Access Compliance Report

Public Rights-of-Way

(Curb Ramps)

Intersection ID: N/A	Main Street: N_COMMUNITY_HOUSE_RD	Cross Street: ENDAHVEN_LN	Location: SW
ADA ID: F6B8081FA607	Ramp Type: Perp	Initial Pass/Fail: Fail	Overall Compliance: No
Severity Score: 22.5			
Codes/Mitigation Info/Possible Solution		Field Measurements/Component Compliance

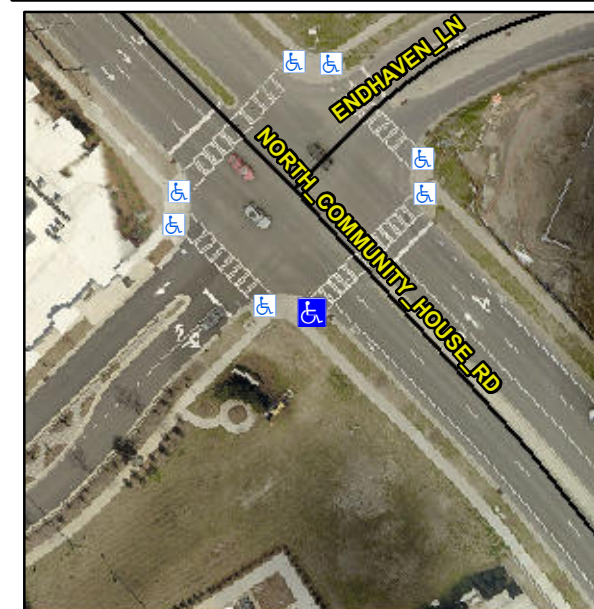
Not Found, R304.5.1, R304.2.2, R304.5.3

Compliance	Description	Data	Compliance	Description	Data
N/A	Ramp Length (in)	81.5	No	Ramp Slope (%)	8.7
No	Ramp Width (in)	47.0	No	Ramp XSlope (%)	2.2
N/A	Flare Type LT	N/A	N/A	Flare Type RT	N/A
N/A	Flare Slope LT (%)	N/A	N/A	Flare Slope RT (%)	N/A
N/A	Flare Traversable LT?	N/A	N/A	Flare Traversable RT?	N/A
N/A	Landing Length (in)	N/A	N/A	DWS Provided?	N/A
N/A	Landing Width (in)	N/A	N/A	DWS Contrast?	N/A
N/A	Landing Slope (%)	N/A	N/A	DWS Length (in)	N/A
N/A	Landing X Slope (%)	N/A	N/A	DWS Full Width?	N/A
N/A	Landing Curb? (Y/N)	N/A	N/A	DWS Offset (in)	N/A
N/A	Shared Landing?	N/A			
N/A	Gutter Ponding?	N/A	N/A	Gutter Slope (%)	N/A
N/A	Gutter Lip Ht (in)	N/A	N/A	Gutter X Slope (%)	N/A
N/A	Painted X Walk1?	Yes	N/A	Painted X Walk2?	N/A
	X Walk 1 Direction	To NE		X Walk 2 Direction	N/A
N/A	X Walk 1 Width (in)	114.0	N/A	X Walk 2 Width (in)	N/A
	X Walk 1 Slope (%)	3.7		X Walk 2 Slope (%)	N/A
	X Walk 1 X Slope (%)	1.9		X Walk 2 X Slope (%)	N/A

Remove & Replace Entire Ramp.
